Recall Code 0828 - Horn Wire Routing for 2004 XB9S, XB9SL and XB12S

Buell Motorcycle Company has determined that a condition, relating to motorcycle safety, exists involving 2004 model year motorcycles built between June 23, 2003 and August 27, 2003. This condition involves the wire that provides power to the horn, which due to mis-routing, can become frayed from contact with the horn bracket mounting bolt. The result is that the horn wire becomes exposed, and when the horn button is pushed, either the horn circuit fuse or the key switch fuse can blow. If the horn fuse blows, the horn and rear brake light will no longer function. If the key switch fuse blows, in addition to the horn and rear brake light not functioning, the vehicle can lose ignition and create a "quit while riding" situation. A "quit while riding" situation could result in an accident.

Figure 1-1. Horn Assembly Behind Windscreen

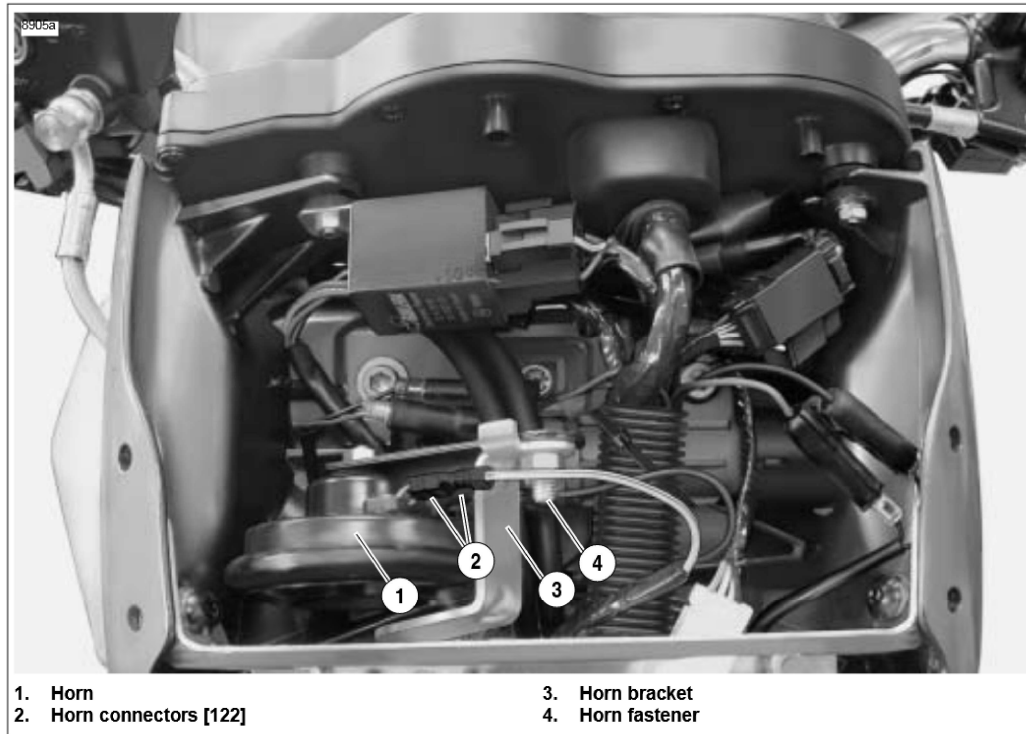
2. Disconnect battery by unthreading fastener and removing negative cable (black) from battery first.
3. Remove windscreen.
4. See Figure 1-1. Disconnect horn connectors [122] (2) and remove horn fastener (4) and horn (1).

Horn bracket (3) should remain attached to headlight support bracket.

5. Install horn (1) using new fastener from kit and tighten fastener (4) to 72-96 in-lbs (8.1-10.8 Nm).
6. Inspect horn wire for damage. If damaged, see WIRE REPAIR SECTION next page.
7. Connect horn connectors [122] (2).

8. Inspect horn wire routing to ensure there is no contact. Correct as necessary.
9. Install windscreen and tighten fasteners to 10-12 in-lbs (1.1-1.4 Nm).
